Skye Canyon Parcel 221B

CITY OF LAS VEGAS		DATE:
INTER-OFFICE MEMORANDUM		July 26, 2018
TO: Land Development Services Department of Building & Safety		FROM: Jennifer Shinn, P.E. <i>JS</i> Flood Control Engr. Associate Department of Public Works
SUBJECT:	COPIES TO:	
Drainage Study for:	Slater-Hanifan Group, Inc.	
Skye Canyon Parcel 2.21B		
Cross Streets:	NEC of Shaumber Rd. and Grand Teton Dr.	Ninety-Five Management, LLC
File Number:	F:\Depot\DSMemos\DS5014A.doc	Bart Anderson, P.E., DevCo
Parcel Number:	126-12-410-001	
Zoning Action:	TMP-73326	
FEMA Flood Zone	YES NO X	
Proposed Storm Drain	YES NO X

The Drainage Study for the subject project has been reviewed and:

DATE: JUNE 2018
DRAFTER: JSR
DESIGNER: JSR
CHECKED: SOA
PROJECT NO. OLY1725.000
EXHIBIT B
SHEET 1 OF 1

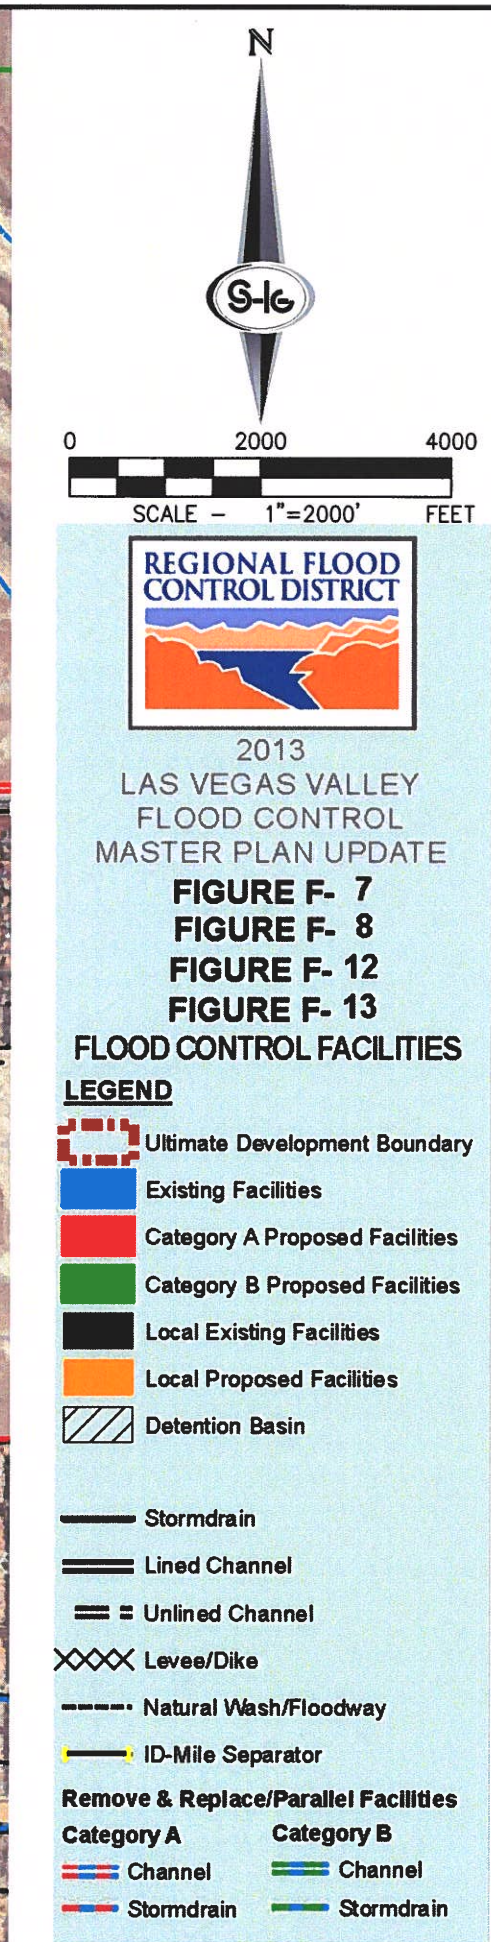
- Label the existing CCRFCD facility within Grand Teton Drive.
- Revise Exhibit B for the following:
 - The flow values shown in the Proposed Condition Flow Rate Summary for WML11W and *ON1 appear to be incorrect. Review and revise the table accordingly.

- Delineate Basins *ON1 and *Trail as well as CP1 on the drainage exhibit.
- Revise the depth values for the Finish Floor Check Table for Lots 84 and 87 through 92 to match the normal depth calculated for Hydraulic Section 3.
